**Town of Londonderry Planning Board  
268B Mammoth Road - Moose Hill Conference  
Agenda  
February 4, 2026  
7:00 p.m.**

- A. Public hearing for an application for formal review of a site plan for forty (40) residential units and a conditional use permit for 1,023 square feet of buffer impacts, including associated site improvements in the Commercial II (C-II) Zone. 225 Rockingham Road, Tax Map 15, Lot 126, Genex Construction Group, LLC (Owner/Applicant).

- C. Public hearing for an application for formal review of a site plan for a 48-unit multi-family residential development and a conditional use permit for 2,808 square feet of wetland impacts and 2,357 square feet of buffer impacts, including associated site improvements in the Commercial 1 (C-1) District. 222 Rockingham Road, Tax Map 15, Lot 150-1, Dark Horse Investments, LLC (Owner/Applicant).

SHEET 2 of 24

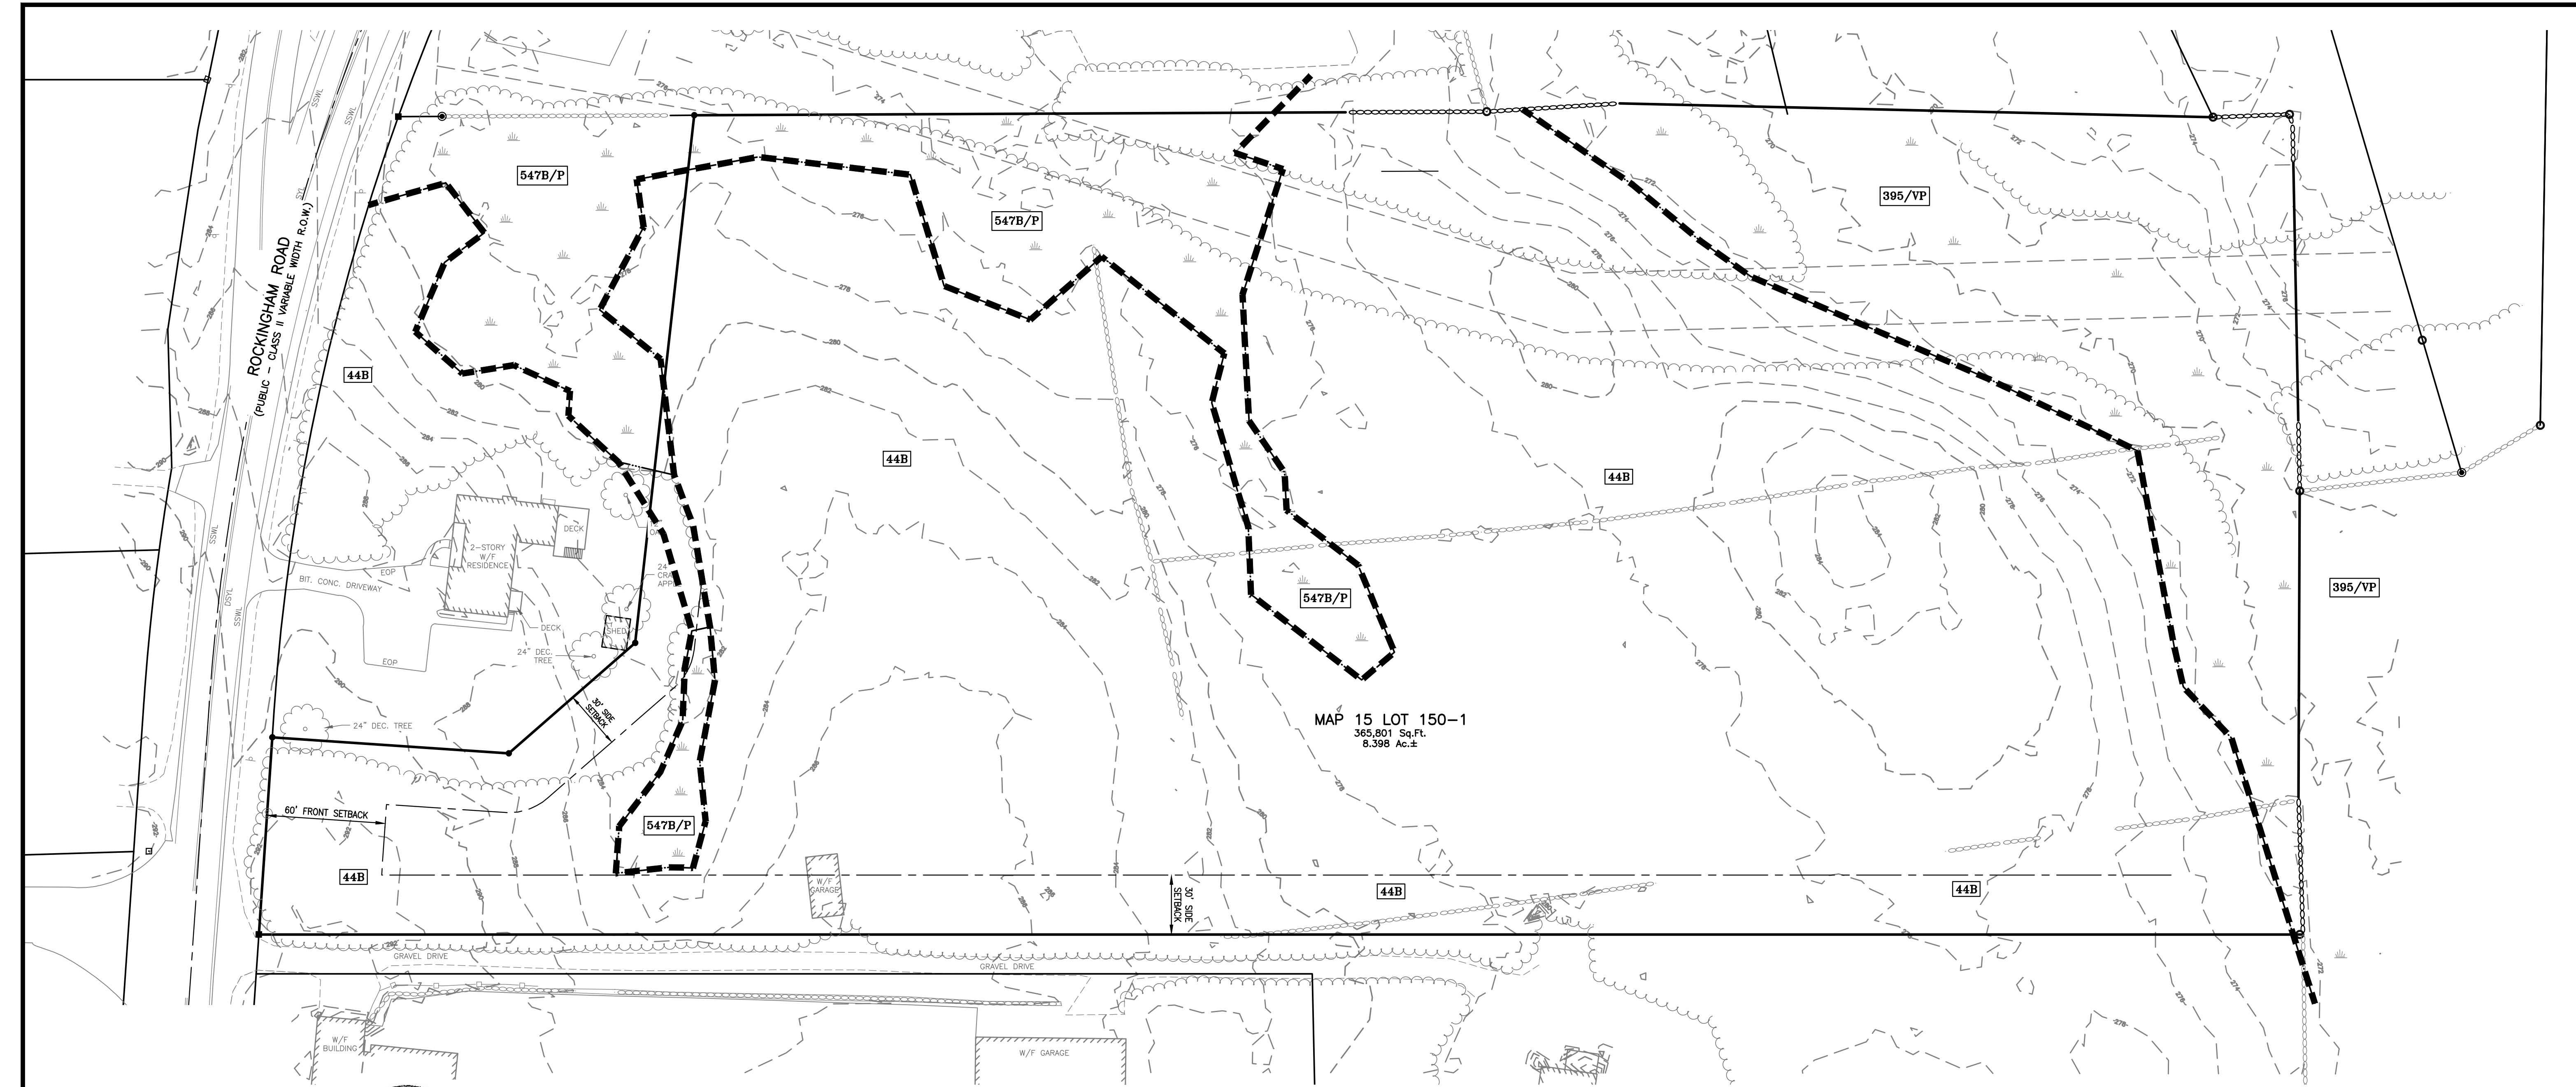
- b) Please remove the Planning Board signature block from the existing conditions plan – sheet 2 and topographic plan – sheet 4 - per section 4.03 of the regulations.

Drawn By: JHD  
Checked By: DGM  
Project: 640  
File: 640-SITE  
SHEET 5 of 24

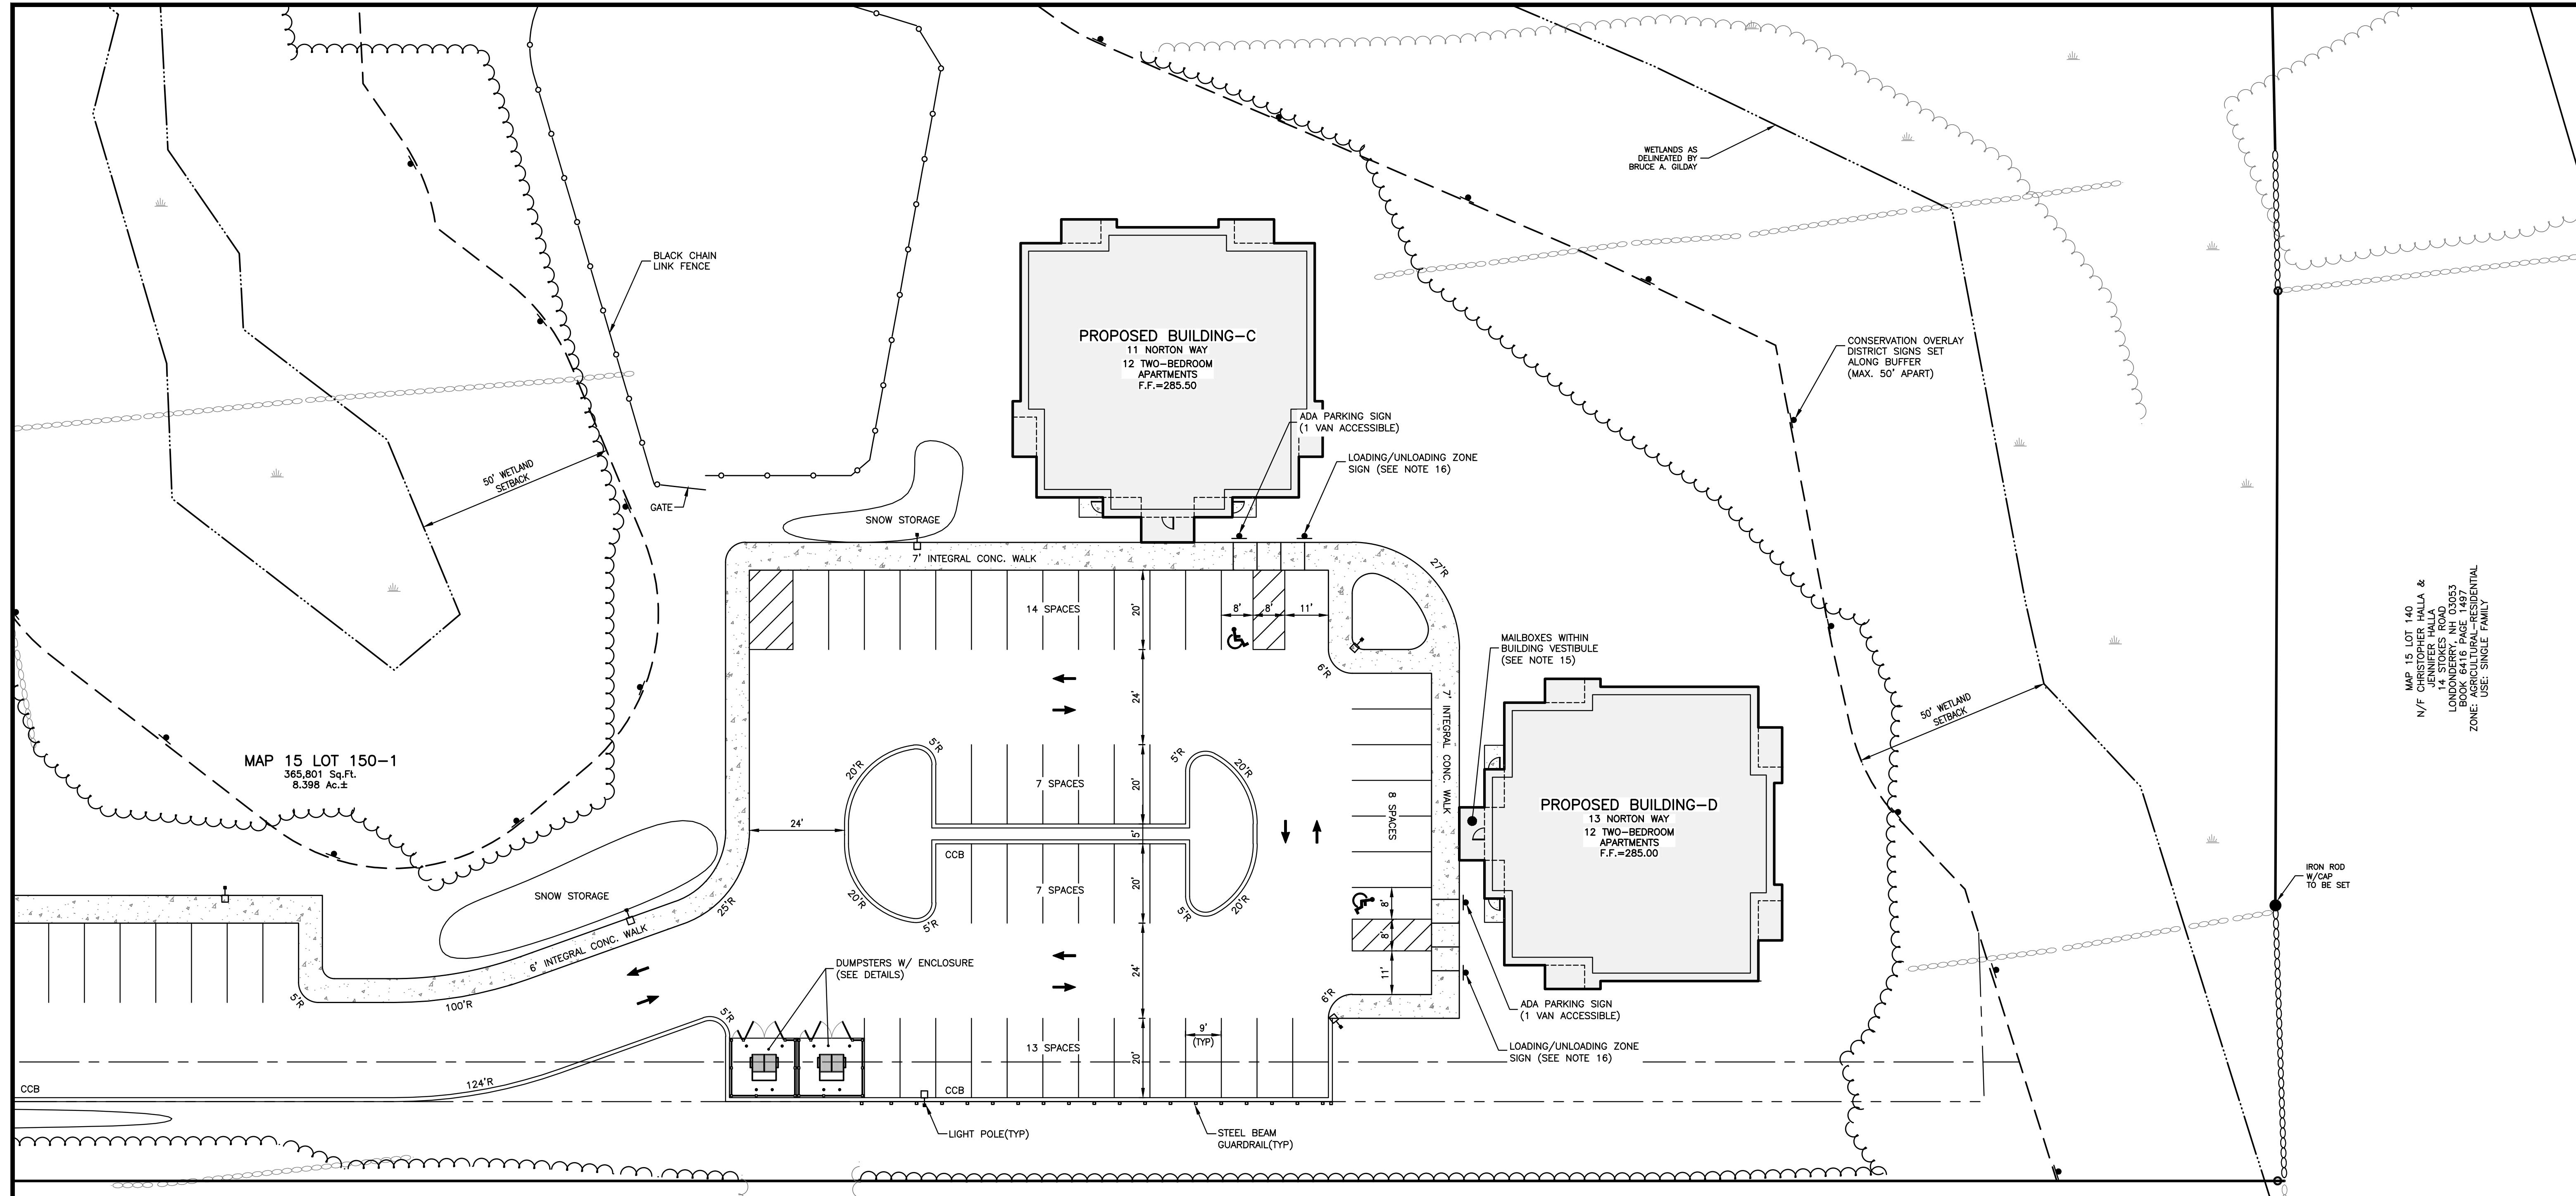
1. The submission information indicates a proposed common driveway to be shared by the two new lots and sheet 5 indicates the improvements for the common driveway and the associated impacts in the updated submission. However, the revised subdivision submission does not include a stormwater analysis/report per section 3.08 of the Subdivision Regulations and item X.3 of the Subdivision Application & Checklist for the indicated improvements to demonstrate the proposed improvements comply with section 3.08.A of no increase in runoff. We recommend the Applicant prepare and provide a stormwater analysis/report that addresses all the proposed development which demonstrates compliance with the Subdivision Regulations in accordance with section 3.08 and also demonstrates compliance with the Town's Stormwater Ordinance and Regulations under this application. The Applicant has noted a waiver has been requested in the response letter, but the request was absent from the submission.

Drawn By: JHD  
 Checked By: DGM  
 Project: 640  
 File: 640-GU  
 SHEET 8 of 24

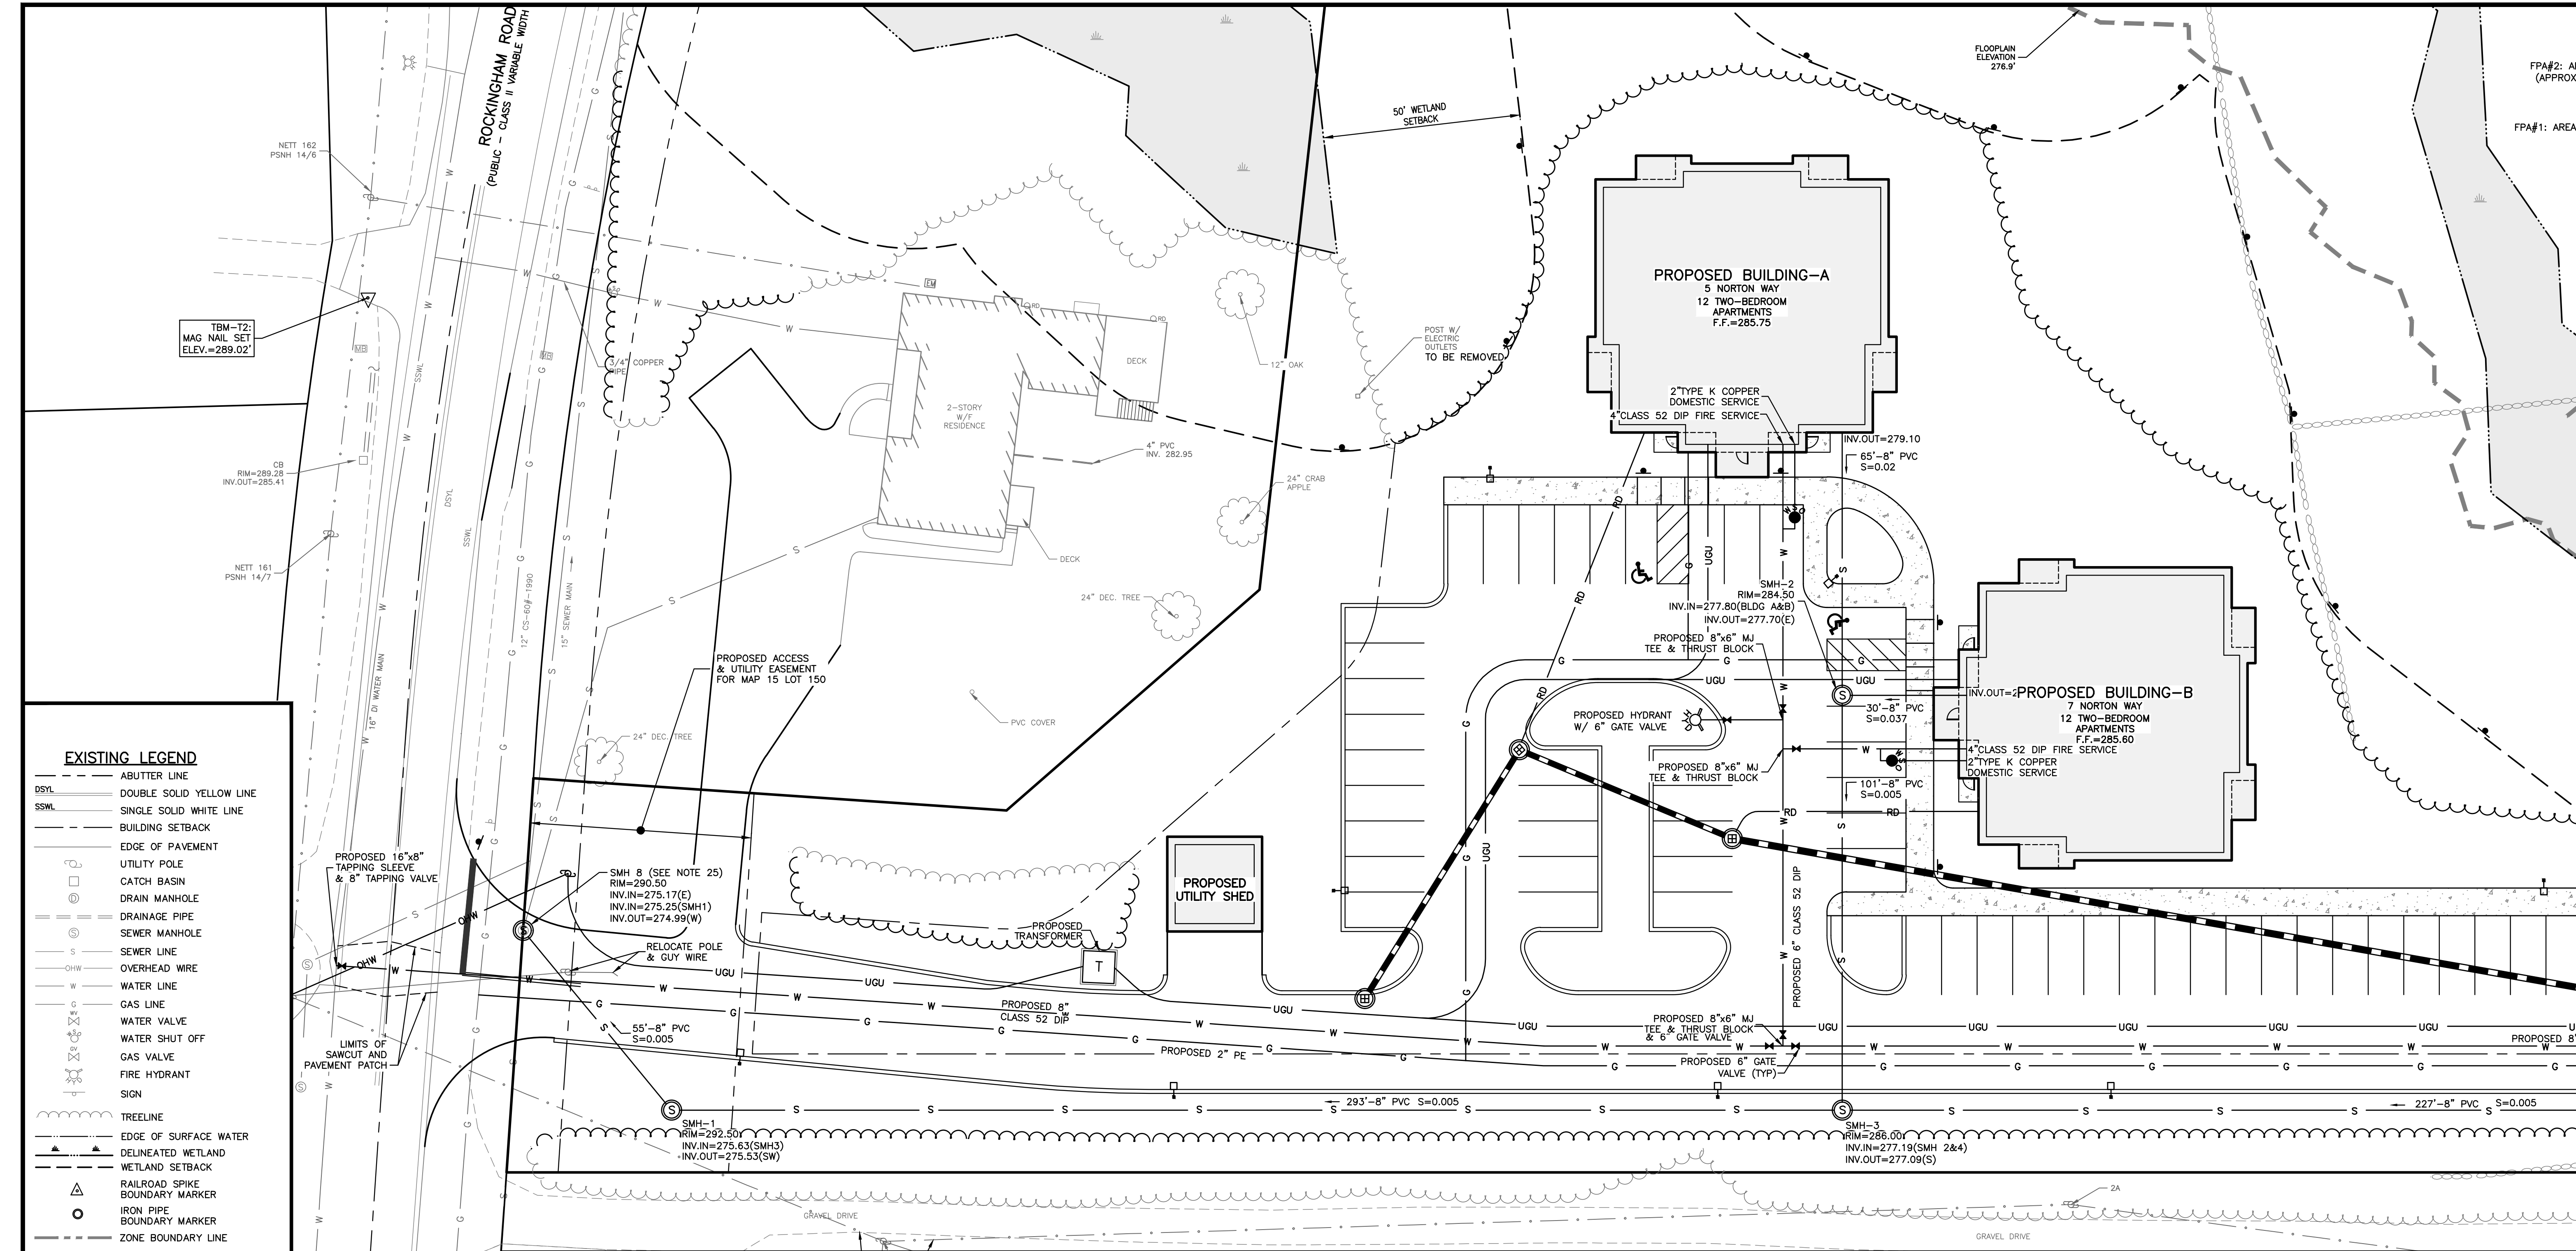
- f. The proposed grading along the easterly side of the driveway and parking lot shown on sheet 8 does not provide a proper 3H:1V embankment as typically requested by the Town. The revised design has noted the 2H:1V embankment slope as riprap. We recommend the design in this 2H:1V area include a guardrail along the parking area to NHDOT standards as typically requested by the Town. Please revise the design as acceptable to the Department of Engineering and Environmental Services.

- g. We recommend note 26 on sheet 10 (utility plan) be copied and provided on the grading plan – sheet 8 since the proposed detention basin grading is located within 5 feet of the existing gas line easement on the subject parcel. In addition, we recommend the Applicant provide documentation from the gas line Owner that they are aware of the proposed work in close proximity to the existing gas main under this project, as noted in the response letter, for inclusion in the Planning Board’s project file.

**TDG Response:** *A table has been added to Sheet 8 summarizing the floodplain impacts.*
